## QHAT advisory note – Changes to threshold requirements

CA-GDL-019a

**EFFECTIVE IMMEDIATELY: Deletion of clause B2.2.1 B iii  
(Removal of level threshold requirement for main entry).**

Technical clarification to Ngā Paerewa Hoahoa Whare Design Requirements Version 1.1

**Level thresholds at the main entry are still required to Accessible homes.**

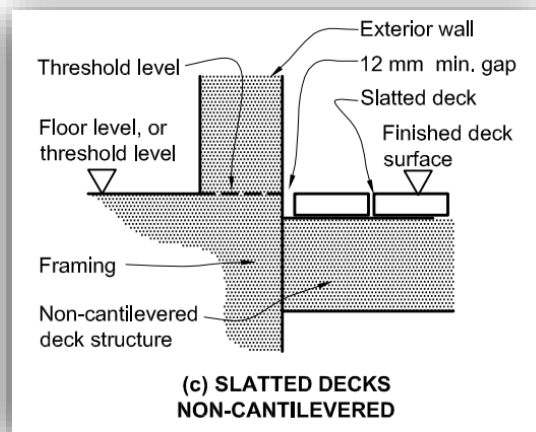
Where a 'step-free' entry or a ramp has been briefed to be delivered as part of the build project, a level threshold *must be* provided to the main entry door (or door served by the ramp) e.g., where an accessible dwelling is proposed.

**Typical example of current main entry threshold detail to be discontinued for standard and FUD homes.**

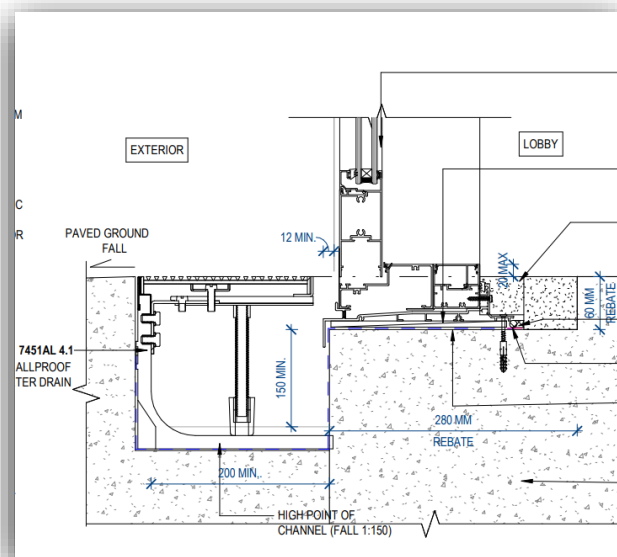
## Deletion of clause B2.2.1Biii removes the current requirement to provide a level threshold at the main entry for both Standard and Full Universal Design (FUD) homes.

Notwithstanding this deletion, homes *must be* delivered with compliant clearances and separations to ground level/concrete to NZBC E2/AS1 figure.65 and Table 18.

A 180mm maximum step up at threshold to *all* exterior entry doors is required (other than where a timber deck/landing is provided – see below).

*E2/AS1 7.1.1, Figure 14 – compliance for timber deck/porch (preferred option when building timber landings and decks)*

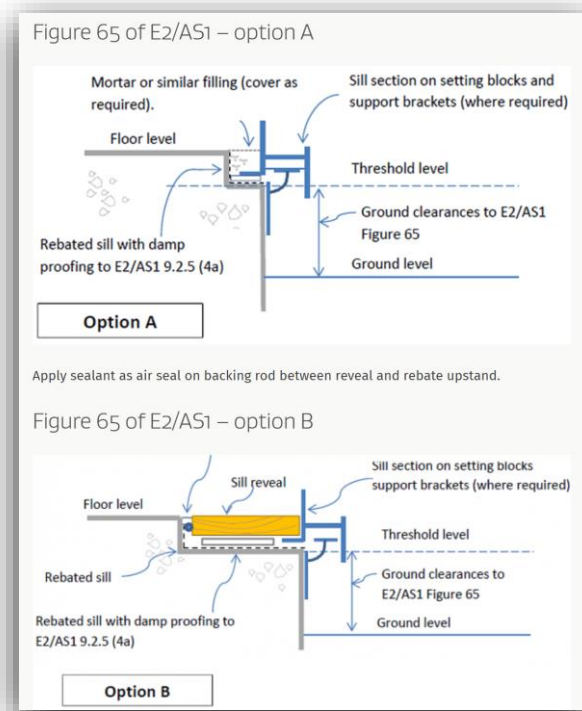
**PLEASE NOTE:** That where a timber deck/ landing is provided at a dwelling entry, a level threshold detail is the *preferred solution* as it can be readily and cost-effectively provided.

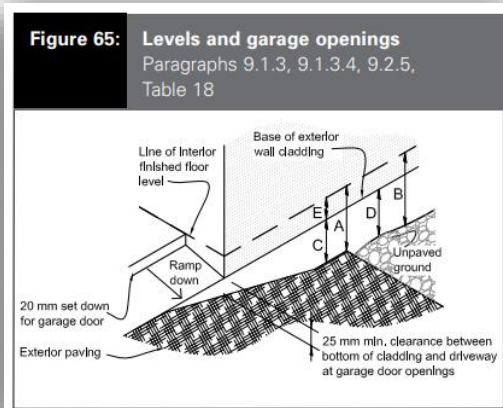
Ensure compliance with clause 9.0 Wall claddings acceptable solution on all builds.  
<https://www.building.govt.nz/building-code-compliance/e-moisture/e2-external-moisture/door-thresholds-e2as1>
